MIAMISBURG CLOSURE PROJECT RISK BASED END STATE VISION

DRAFT
February 2004

Figure 4.1a2 Current Conceptual Site Model for Hazard Area 1

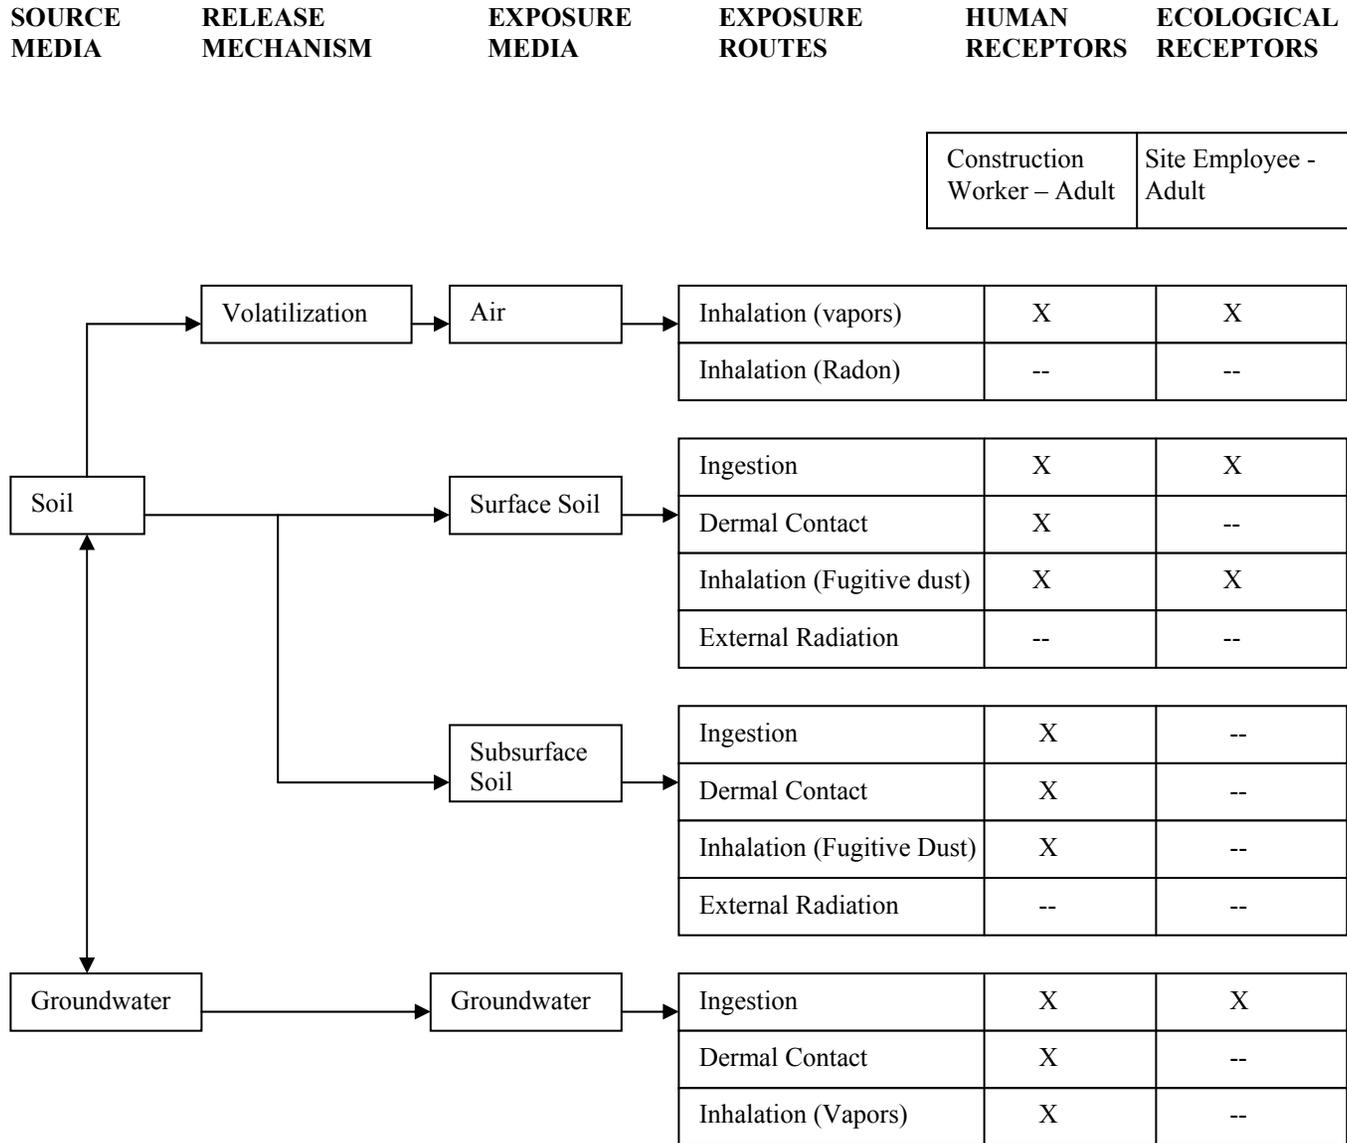
34. Figure 4.1a2. 1) Should surface water be a potential exposure media? There are surface water (ponds) and the seeps.

35. **Figure 4.1a2** – This CSM used to reflect the current Hazard Area 1 should include surface soil dermal contact and external radiation and subsurface external radiation for the construction worker receptor. In addition, the site employee should have a complete pathway for surface soil external radiation.

35. **Figure 4.1a2** – This CSM used to reflect the current Hazard Area 1 should include surface soil dermal contact and external radiation and subsurface external radiation for the construction worker receptor. In addition, the site employee should have a complete pathway for surface soil external radiation.

Figure 4.1b2 End State Conceptual Site Model for Hazard Area 1

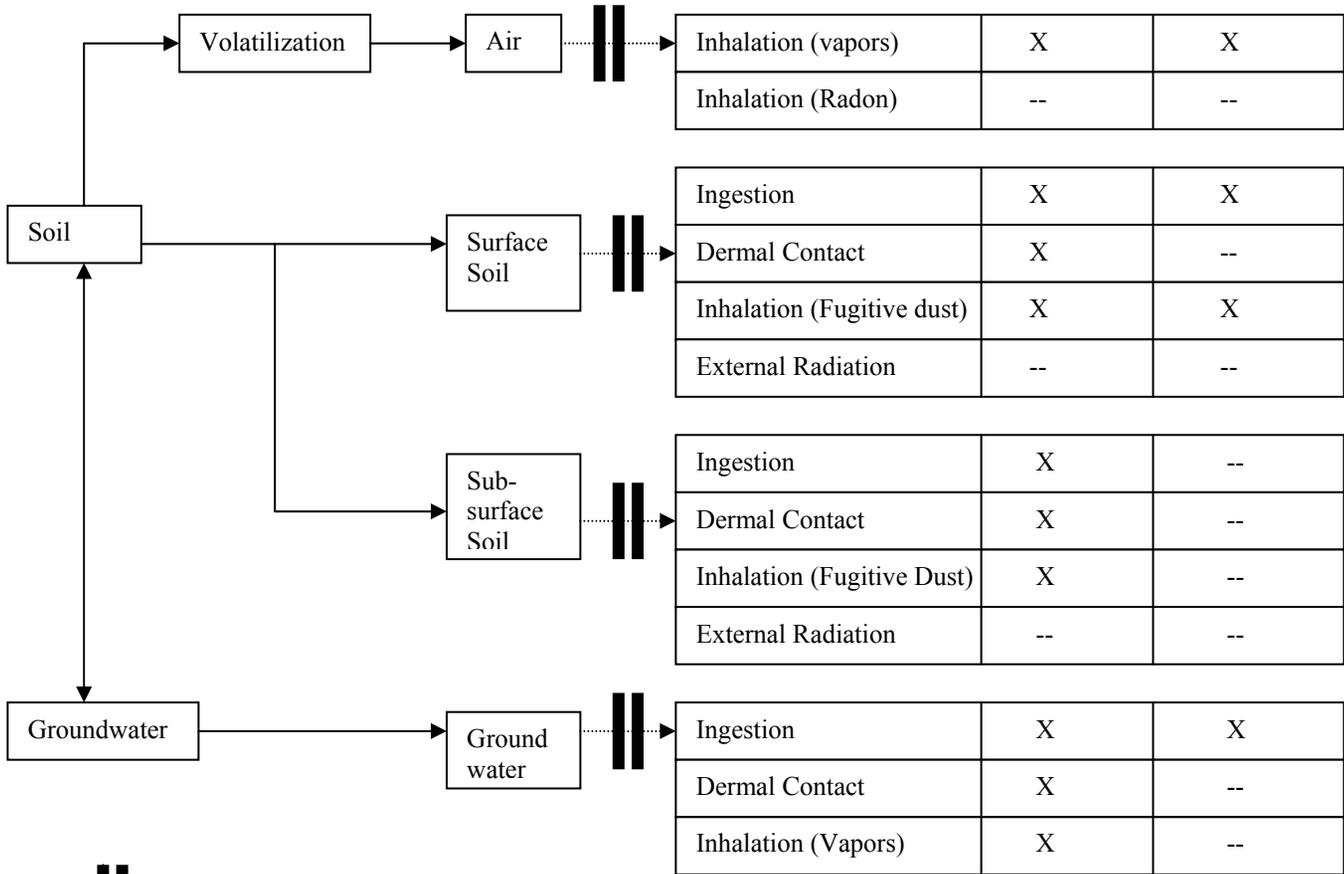
35. Figure 4.1b2. 1) The surface soil and subsurface soil pathways are not blocked. If the engineered landfill and all the hazardous and radiological waste below it and the pond remain and this area is transferred to MMCIC for development, the current remedy is not protective. There is an exposure pathway for the construction worker. 2) Should surface water be a potential exposure media? There are surface water (ponds) and the seeps.

36. **Figure 4.1b2** – The changes requested in comment 35 apply to this figure. Please explain how the surface and subsurface soil pathways will be blocked.

36. **Figure 4.1b2** – The changes requested in comment 35 apply to this figure. Please explain how the surface and subsurface soil pathways will be blocked.

28. Figure 4.1b2. The surface soil and subsurface soil pathways are not blocked. If the engineered landfill and all the hazardous and radiological waste below it and the pond remain and this area is transferred to MMCIC for development, the current remedy is not

Figure 4.2b2 End State Conceptual Site Model for Hazard Area 2

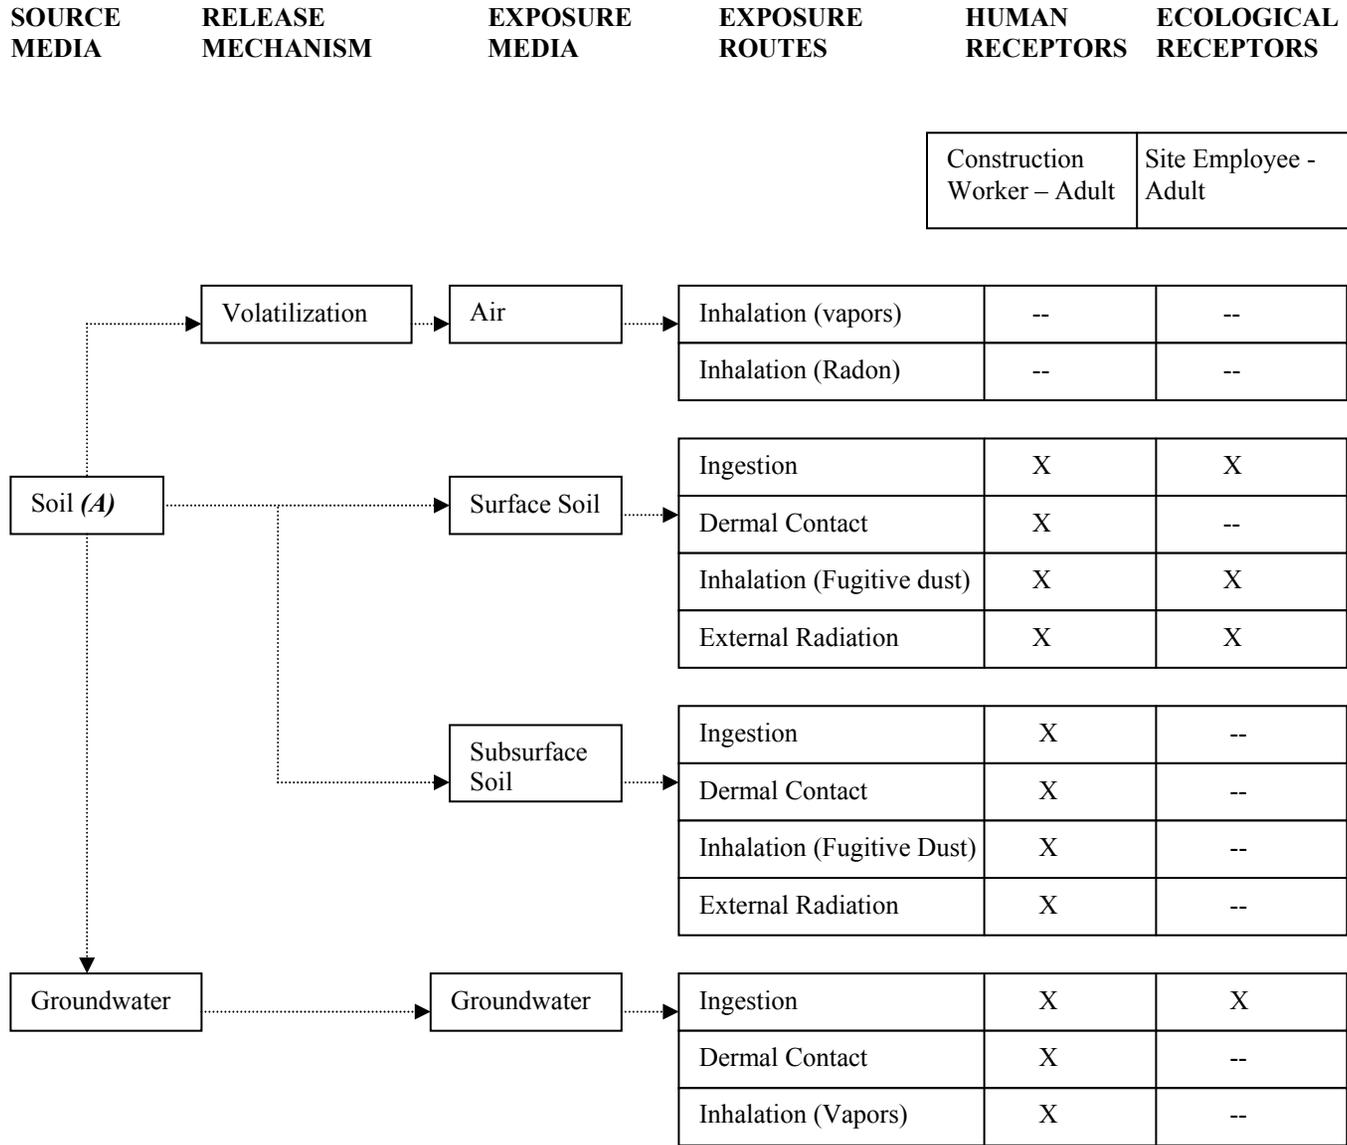
38. Figure 4.2b2. 1) DOE's plan to leave behind the historical landfill and the 1976 mixed waste engineered landfill does not remove the source term as indicated on this drawing. Please correct.

39. **Figure 4.2b2** – Given that residual levels of contamination will remain on the Mound site, this figure is misleading. The soil pathway is not an incomplete pathway unless the entire site is paved or access to soil is restricted. In addition, an explanation on why the air and ground water pathways are incomplete should be made in the text under Section 4.2.

39. **Figure 4.2b2** –Given that residual levels of contamination will remain on the Mound site, this figure is misleading. The soil pathway is not an incomplete pathway unless the entire site is paved or access to soil is restricted. In addition, an explanation on why the air and ground water pathways are incomplete should be made in the text under Section 4.2.

15. **Figure 4.2b2** – Given that residual levels of contamination will remain on the Mound site, this figure is misleading. The soil pathway is not an incomplete pathway unless the entire site is paved or access to soil is restricted. In addition, an explanation on why the air and ground water pathways are incomplete should be made in the text under Section 4.2.
